# THE CANARD PUSHER

No. 58

Jan., 1989

CS132L-R

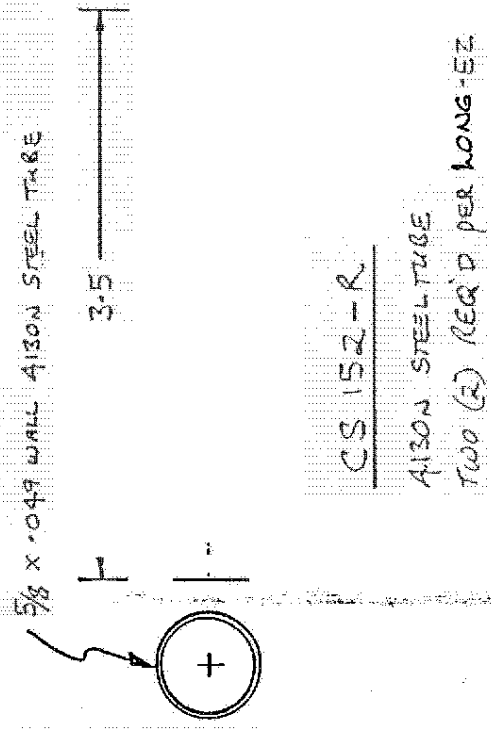
RAF has recently received two separate reports of failures of one of the CS132L weldments, the belhorn, which drives the aileron out in the wing roots. One of these belhorns has had lightening holes bored through the .050 steel belhorn and it cracked through one of these holes. However, the second one was as received from Brock and it cracked across at the edge of the weld around the tube. Prior to the failure of the belhorn this builder pilot had had to replace the rod end that bolts to this belhorn, at least twice over the past 350 flight hours, due to the rod end being "pounded out" until it was dangerously loose.

built and flight tested a new aileron belhorn. Drawings for this new part have been sent to Ken Brock Mfg. and Ken will have these parts available as soon as possible. We will provide a drawing of the new belhorn in this CP for those people who would like to make these parts themselves. (see sketch, page 15)

The new part, part number CS132L-R, has two arms instead of one which will more than quadruple the stiffness of the system and will also provide redundant links in the aileron system as well as providing positive retention of the rod end in the event of a ball slipping out.

If you absolutely insist on flying before the new belhorn is replaced, a careful examination of your CS132L belhorns are mandatory. Use a bright light and a magnifying glass. Examine the area shown in the sketch while gently flexing the CS132L

left and right. Any sign of a crack starting requires immediate grounding of the aircraft until the new CS132L-R is installed. Examine the rod ends bolted to the CS132L. Look for a loose ball, or play in the rod end in the fore/aft plane. A worn rod end must be replaced before flight and you should realize from the above discussion that a worn rod end almost certainly indicates that a belhorn failure is imminent. If you have steel tube push rods (CS132L), your belhorns are definitely more suspect. If you have worn rod ends, do not fly until you replace the belhorns and rod ends. Even if everything looks OK, replace belhorns within the next 25 hours of flight. The CAD plated CS132L belhorns should not be painted since the paint may hide a crack.

MAN-GRD: Long-EZ and VariEze - see section on belhorn failure. Replace aileron belhorns within the next 25 hours of flight. If ailerons are vibrating, you must re-balance.

4130N STEEL WELDMENT (NORMALIZED)  
TWO (2) REQ'D PER LONG-EZ

CS152-R  
4130N STEEL TUBE  
TWO (2) REQ'D PER LONG-EZ

NOTE: NOSE UP STATIC

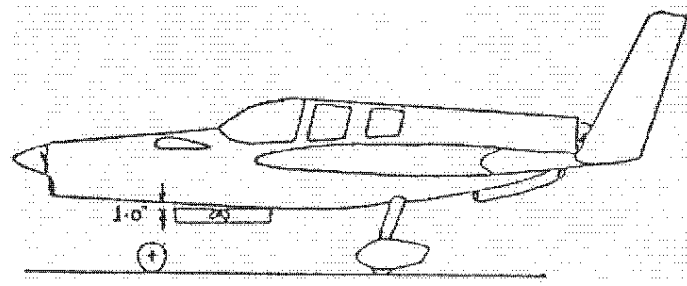
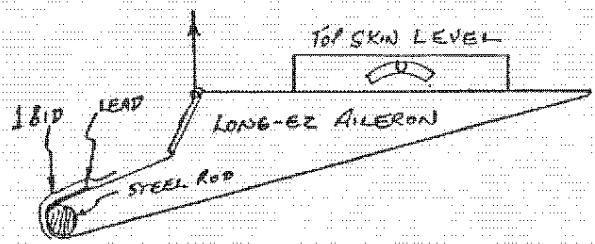
The nose wheel geometry should be set with ZERO weight on the nose wheel, to 0.6/0.8 inches aft of the steering pivot line using the Mooney spacer washer (SB #20-202-3, 1-1/4

OD x 1.010 ID x .120 thick, 4130 N steel finished in zinc chromate). John Steichen suggests that it may even take two of these washers, at least it did on his 4 donut Mooney nose gear. (see sketch, page 15)

Another factor that may influence the likelihood of shimmy, and/or divergence, is rotation speed. If your Defiant rotates at 60 to 65 KIAS, you may not see any shimmy or steering divergence simply because you have not reached the speed at which either of these phenomenon may have occurred. Some Defiants do not rotate until indicating 80 Kts or more. This may be caused by one or more of the following problems: Forward CG, or too far forward CG. Two large people in the front, nothing in the rear seat, no baggage and minimal fuel will put your CG forward. Fill her up with gas, and the CG will march rearward. Main gear axle centerline too far aft will cause the Defiant to act as though it has a forward CG condition while rolling on the runway but may be normal to aft CG once airborne. Having the main gear too far aft will really extend the take-off roll and will require a higher than normal rotation speed. This is tough to fix. Take great care while ~~building not to end up with this problem.~~ Do not be tempted to move the axle centerline forward either, because this will result in a real problem when loading baggage. The Defiant may tip over on its winglets and could break the prop. Put the main gear axles where the plans call for them to be. Ground attitude. A nose down ground attitude puts the canard and the wings at a negative angle of attack during the take-off roll and can greatly increase the rotation speed causing you to use a lot more runway and putting your nose wheel at risk due to excessive speed. Even a correctly set up nose gear may shimmy if it hits ruts or bad bumps at too high a speed. If your Defiant sits nose low with both engines installed and some fuel, perhaps 1/3 on each side, you have a problem. Burt's prototype, N78RA, with the above conditions sits with the flat bottom (from forward firewall aft 3 feet or so) slightly nose up. Check with a two foot level held bubble level. (see sketch, page 15)

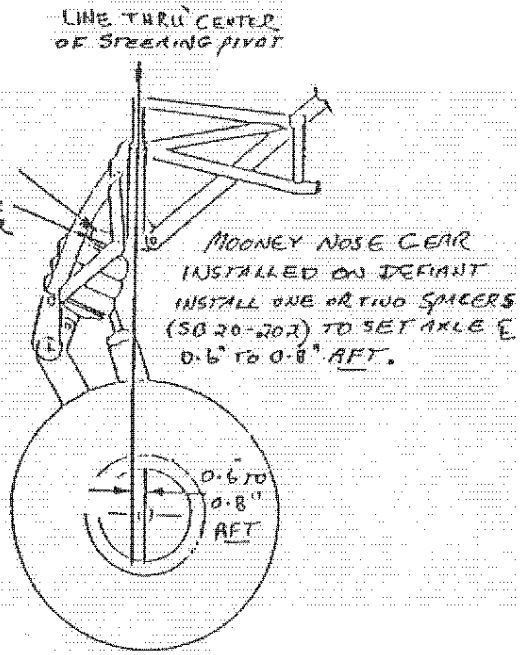
The easiest way is to get some lead ribbon from a golf pro shop and stick it to the top of the aileron leading edges, full span, until it balances top skin level. Lay up one ply of BID to permanently secure the lead to the aileron leading edge. (see sketch, page 15)
